Formal Interpretations *Guidelines for Design and Construction of Hospitals, 2018 edition*

Guidelines edition: **2018 Hospital**

[Excerpt] Table 2.1-1: Electrical Receptacles for Patient Care Areas in Hospitals

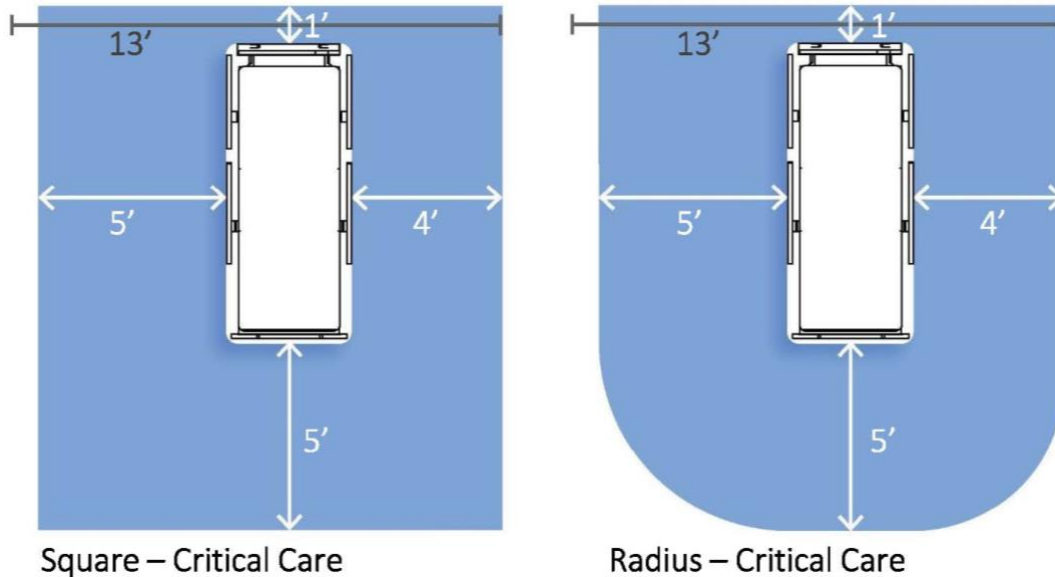
Question: What is the intent of the requirement for two receptacles on every wall of a medical/surgical patient room? We have designed a room that will have six walls, two or three of which would have no receptacles on them:

The rooms are designed with 16 or 17 duplex receptacles on three or four walls when possible. Because of the room configuration, placement of two receptacles on each wall as required in Table 2.1-1 is not always possible.

Response: When the table was developed many editions ago, the assumption was the patient room would be rectangular with four well-defined walls: a headwall and three other walls around the patient station/bed. The minimum number of single receptacles in the table totals 12 for the medical/surgical patient room, which was the intention; these receptacles can be provided in single,

The interpretation committee agreed the intention is for the number of receptacles in a medical/surgical patient room to agree with the number required at the patient bed location in the governing editions of NFPA 99: *Health Care Facilities Code* and NFPA 70: *National Electrical Code*. Additional receptacles shall be provided to support clinical functions and the personal needs of the patient and visitors.

⁴The number of receptacles at the patient bed location for these spaces is intended to agree with the number required in the governing editions of NFPA 99: *Health Care Facilities Code* and NFPA 70: *National Electric Code*. Additional receptacles shall be provided to support clinical functions and the personal needs of the patient and visitors.
